Answer to Reviewers' Comments

Reviewer #1

Fig. 1: Taken from supplementary material Figure S1 of Bose et al. (2021).

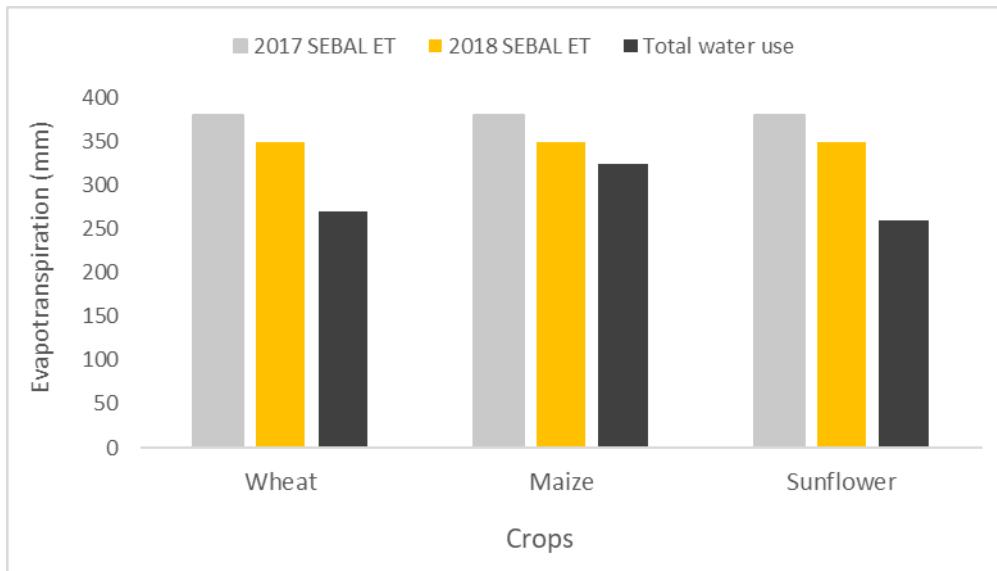
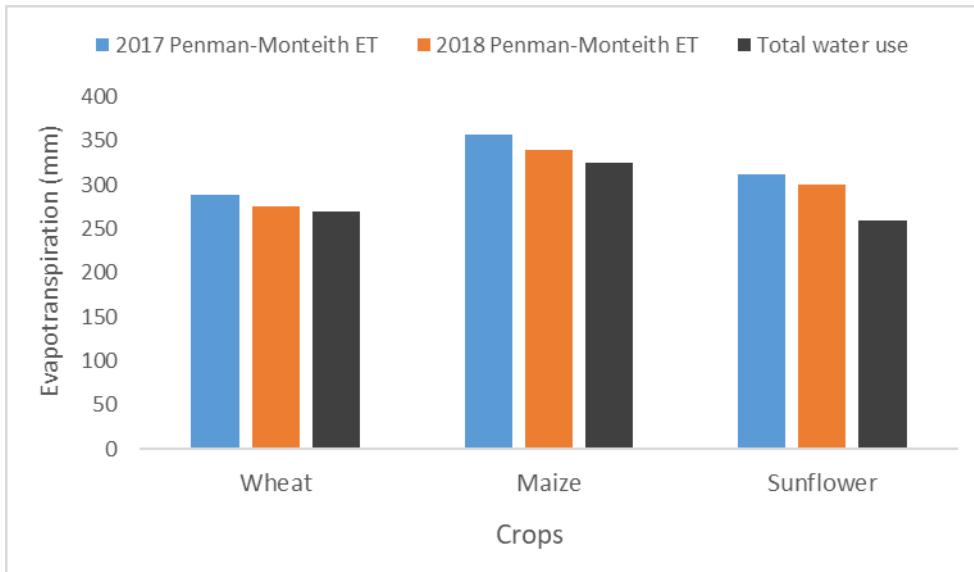
2. Validation: even though I appreciate authors' efforts in this sense, it is not carried out in a rigorous way. It targets other areas (with different climate conditions) and likely different vegetation/crop patterns. In addition, SEBAL, which is the basis for ET calculation for sDRIPS, is involved in OpenET also. If a direct validation is not possible, authors should just look for and mention previous studies validating SEBAL in several climate context (possibly involving the one of interest) to support the method reliability.

We thank the reviewer for this constructive comment. While direct field-scale validation within the TBP command area was not feasible due to the absence of lysimeter or flux-tower measurements, we have strengthened the manuscript by explicitly referencing validation studies of SEBAL and Penman-Monteith ET in agroclimatic conditions comparable to our study region.

Notably, the study by Bose et al. (2021), which underpins the original development of the sDRIPS framework, conducted lysimeter-based validation at the Bangladesh Agricultural Research Institute (BARI) in Gazipur from 2017 to 2018. Their results demonstrated:

- strong correlation between Penman-Monteith estimates and lysimeter observations ($r \approx 0.87-0.88$; errors 2-10% for wheat/maize), and
- SEBAL errors ranging from ~8% to 46%, which Bose et al. (2021) largely attributed to pixel-point mismatch and mixed land cover near the lysimeter site.

Importantly, Bose et al. (2021) relied on Landsat 7 thermal data (100 m), whereas the current study uses Landsat 8/9 thermal bands (30 m), which substantially reduce mixed-pixel effects and are expected to improve ET estimation accuracy.

Fig. 3: OpenET Timeseries along with sDRIPS estimates for the studied region in California

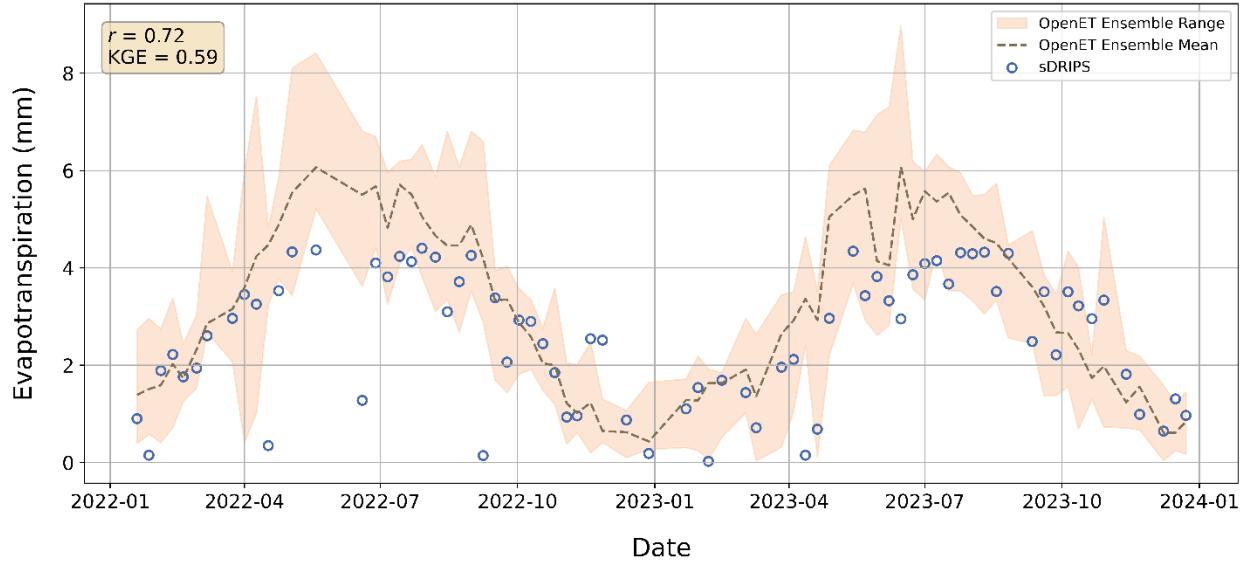
Fig 9 and 10: On top of the criticism to the significance of validation, description here is qualitative only, as no metrics are provided

We thank the reviewer for their constructive feedback. In the revised manuscript, we have complemented the qualitative discussion of Figs. 9 and 10 with quantitative performance metrics (Lines 540–548). For the California region (Fig. 9), sDRIPS shows strong temporal agreement with the OpenET ensemble mean ($r = 0.72$), with an RMSE of 1.37 mm/d, MAE of 0.99 mm/d, and a moderate negative bias of -0.68 mm/d. The corresponding Kling-Gupta efficiency (KGE = 0.59) indicates good overall agreement when jointly accounting for correlation, bias, and variability.
